Access Compliance Report Public Rights-of-Way (Curb Ramps)

Intersection ID: N/AMain Street:SPRING FROST CTCross Street: N/ALocation:NEADA ID: C1AEB15558D5Ramp Type:PerpInitial Pass/Fail:FailOverall Compliance: NoSeverity Score:33.75

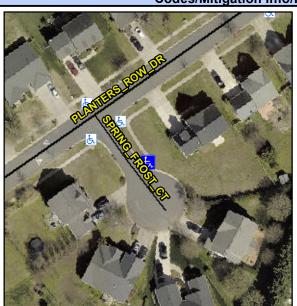
R304.5.1, R304.5.3

Field Measur	ements/C	<u>ompo</u>	nent Compliance	
Compliance Description		Data	Compliance Description		Data
N/A	Ramp Length (in)	82.0	Yes	Ramp Slope (%)	5.7
No	Ramp Width (in)	46.0	No	Ramp XSlope (%)	7.3
N/A	Flare Type LT	N/A	N/A	Flare Type RT	N/A
N/A	Flare Slope LT (%)	N/A	N/A	Flare Slope RT (%)	N/A
N/A	Flare Traversable LT?	N/A	N/A	Flare Traversable RT?	N/A
N/A	Landing Length (in)	N/A	N/A	DWS Provided?	N/A
N/A	Landing Width (in)	N/A	N/A	DWS Contrast?	N/A
N/A	Landing Slope (%)	N/A	N/A	DWS Length (in)	N/A
N/A	Landing X Slope (%)	N/A	N/A	DWS Full Width?	N/A
N/A	Landing Curb? (Y/N)	N/A	N/A	DWS Offset (in)	N/A
N/A	Shared Landing?	N/A			
N/A	Gutter Ponding?	N/A	N/A	Gutter Slope (%)	N/A
N/A	Gutter Lip Ht (in)	N/A	N/A	Gutter X Slope (%)	N/A
N/A	Painted X Walk1?	No	N/A	Painted X Walk2?	N/A
	X Walk 1 Direction	To SW		X Walk 2 Direction	N/A
N/A	X Walk 1 Width (in)	N/A	N/A	X Walk 2 Width (in)	N/A
	X Walk 1 Slope (%)	3.3		X Walk 2 Slope (%)	N/A

Remove & Replace Entire Ramp.
